## JPB CAC

**Subject:** Item H. CONFERENCE WITH LEGAL COUNSEL—PENDING LITIGATION

Roland Lebrun
<a href="mailto:ccss@msn.com">ccss@msn.com</a>
Brisbane Baylands Draft EIR
January 19 2014

A OVERALL FACILITY PLAN

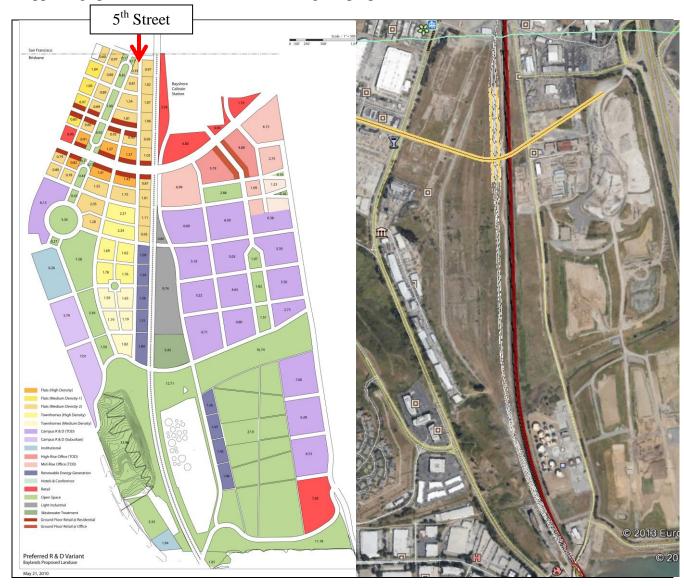
Each LMF consists of 3 tracks in the first phase followed by 3 additional storage tracks in a later phase:

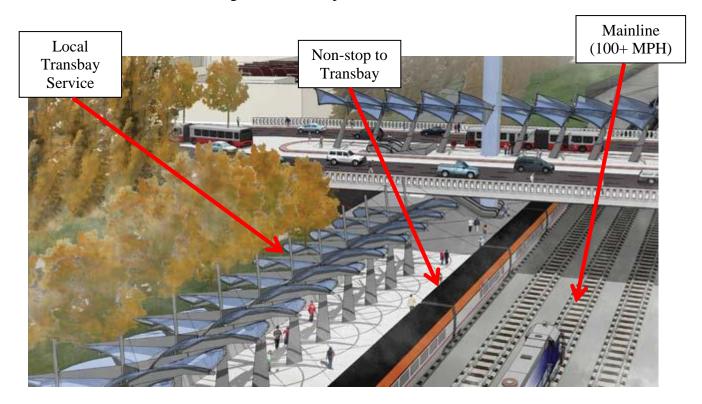
The relocated Bayshore station would have two additional tracks to facilitate cross-platform transfers between Baby Bullets (5-minute non-stop to Transbay) and locals stopping at Oakdale, 22<sup>nd</sup> Street, Mission Bay and the Transbay Terminal. The additional station and turnaround tracks would support a capacity of 12 trains/hour between Brisbane and Transbay, 10-20 years ahead of the rest of the Peninsula (Policy 6-12).

The impacts caused by the higher speeds of express trains should be mitigated by creating embankments on both sides of the tracks thereby giving the impression that the proposed Geneva Avenue extension is at grade while the platforms and the tracks are in a trench.

## Platform lengths.

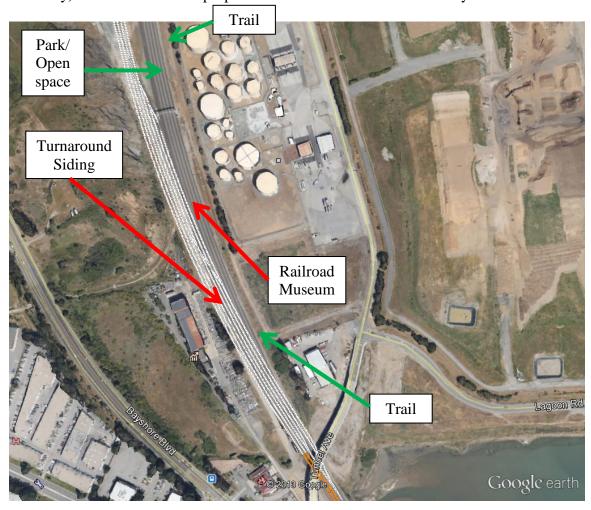
Please refer to "Platform Dimensions" on page 13 of Chapter 3 of the Caltrain Engineering Standards: <a href="http://www.caltrain.com/assets/\_engineering/engineering-standards-2/criteria/CHAPTER3.pdf">http://www.caltrain.com/assets/\_engineering/engineering-standards-2/criteria/CHAPTER3.pdf</a> : "The standard platform length shall be 700 feet to accommodate a six (6) car train consist. Platform design shall consider or not preclude a possible expansion of platform length to 1000 feet"

The DEIR should consider this 1,000-foot requirement because it would enable a Bayshore Caltrain station entrance at Beatty Avenue which is within walking distance of the Schlage Lock development. The DEIR should also consider extending the platforms south of Geneva Avenue to match Transbay's 1,330-feet platform lengths for two reasons: support for double-length Caltrain consists capable of transporting 2,000 passengers to/from special events in downtown San Francisco and/or Brisbane and the ability to disembark and turn around full-length HSR trains in case of an emergency between Brisbane and the Transbay terminal.
